1. SUBMITTAL TYPE: (Is this a resubmittal? Yes ☐ No ☒)			
Deferred Submittal ☐	Addendum Number: 01	Revision Number:	CCD Number: Category A ☐ or B ☐
2. PROJECT INFORMATION:			
School District/Owner: San Beranrdo City USD		DSA File Number: 36 H7	
Project Name/School: Indian Springs HS - Health Center		DSA Application Number 04 123900

ADDENDUM NO. 1

Indian Springs High School – Health Center

DSA #04-123900 FILE #36-H7 RCA Project No. 1-78-50

CODE ANALYSIS PLAN	SCALE: 1" = 10'-0"	1
--------------------	-----------------------	---

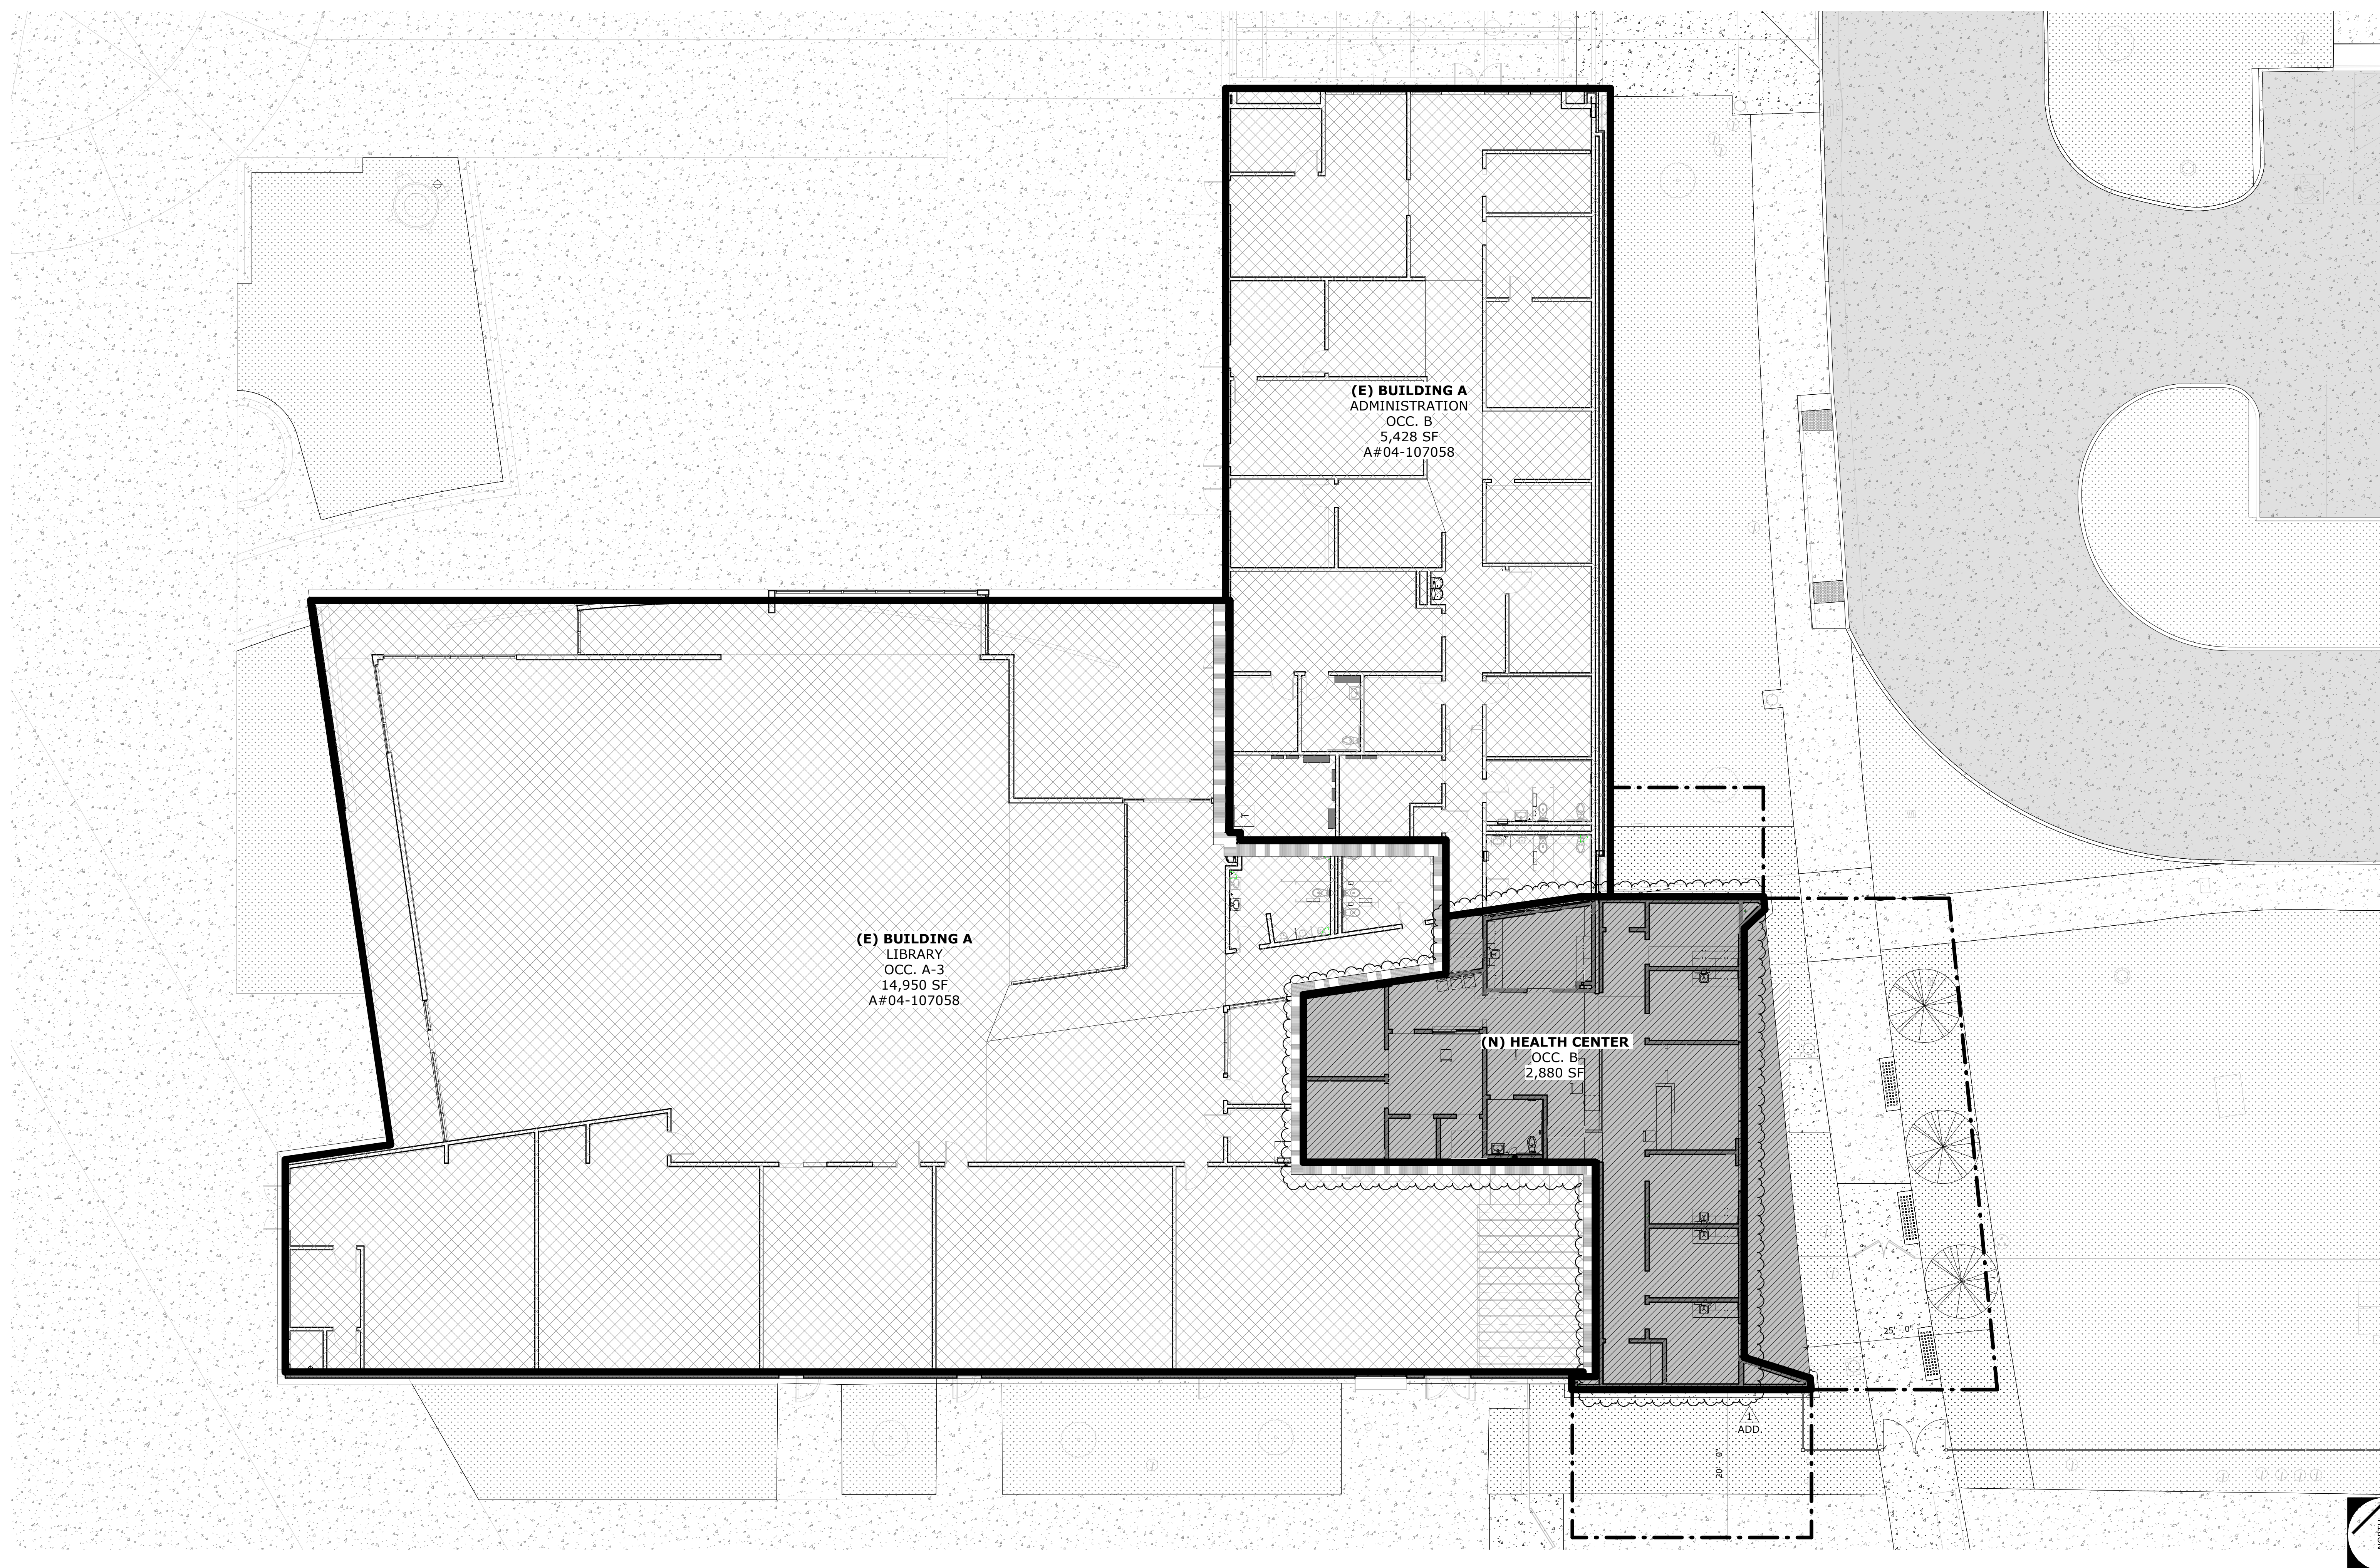
- Item No. 1.7 Reference Sheet G-2 – CODE ANALYSIS FLOOR PLAN
1.7.1 Replace Sheet G-2 and revise per clouded areas & items listed below:
 (a) Revised floor plan background. No changes to code analysis.

EGRESS & SIGNAGE PLAN

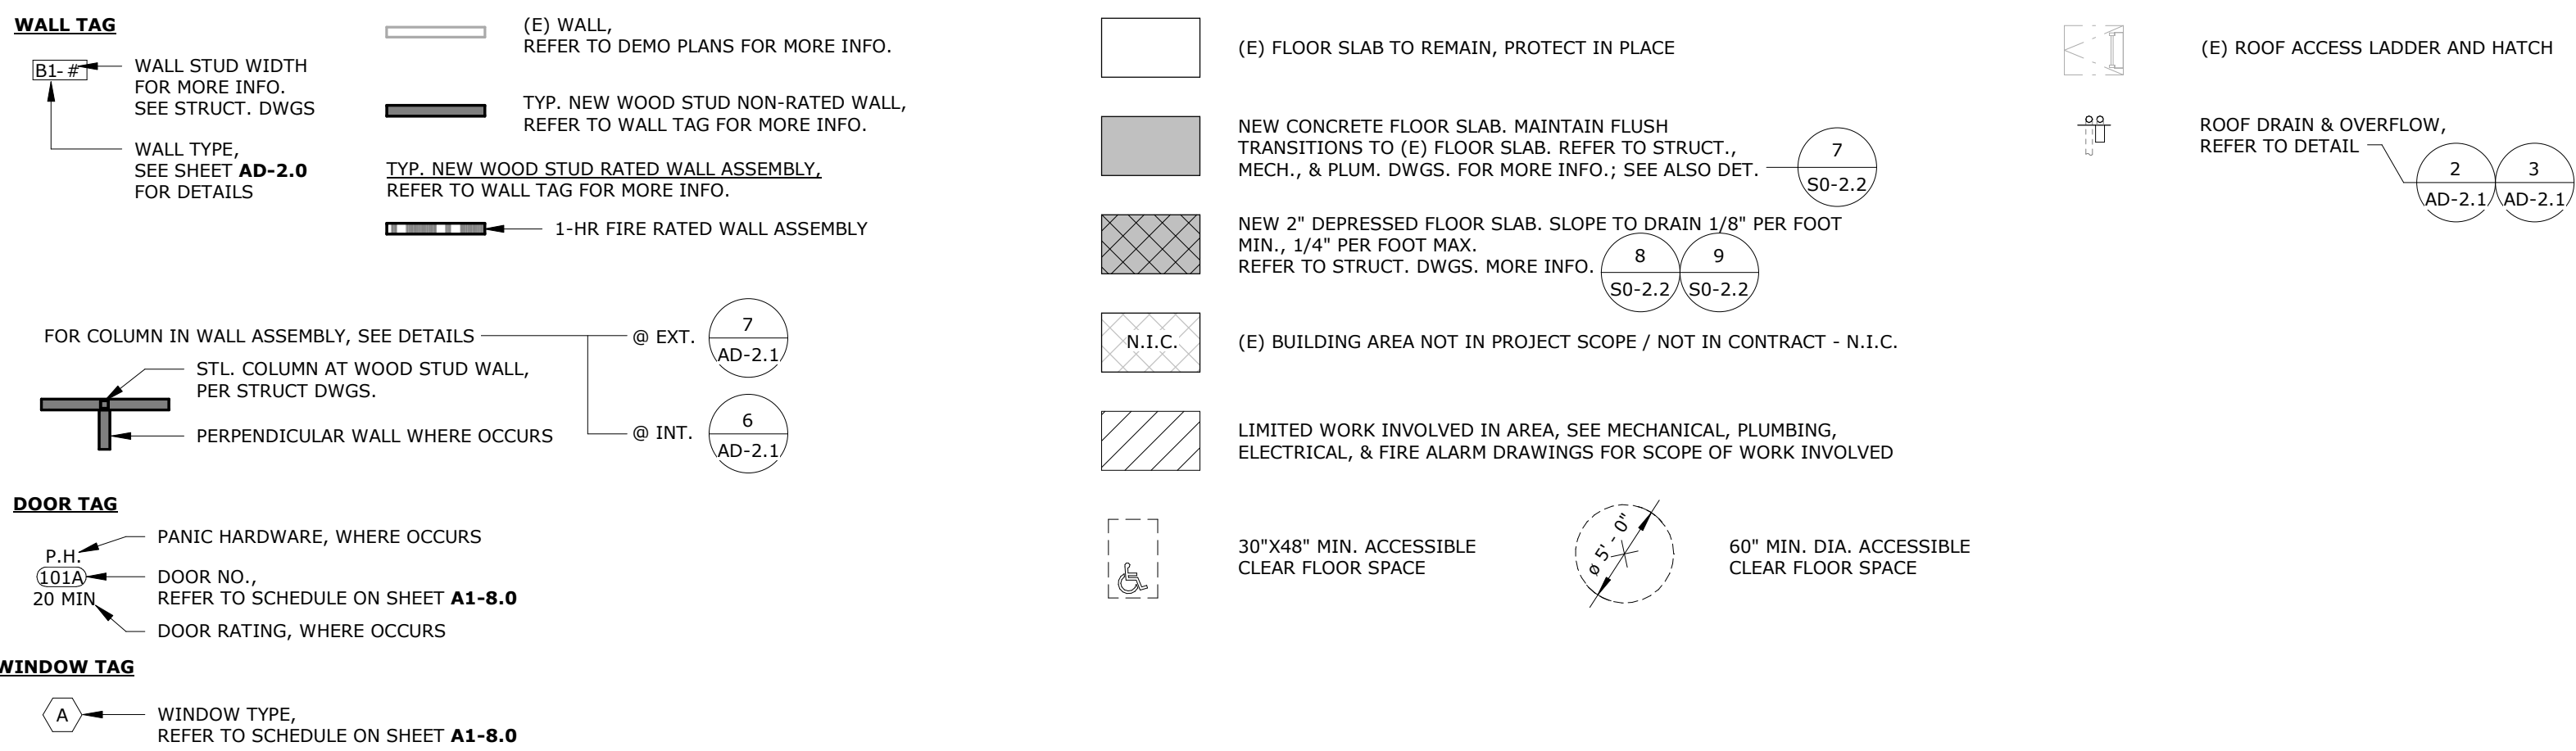
- Item No. 1.8 Reference Sheet G-4 – EGRESS & SIGNAGE PLAN
1.8.1 Replace Sheet G-4 and revise per clouded areas & items listed below:
 (a) Revised egress & signage to reflect the revised floor plan layout
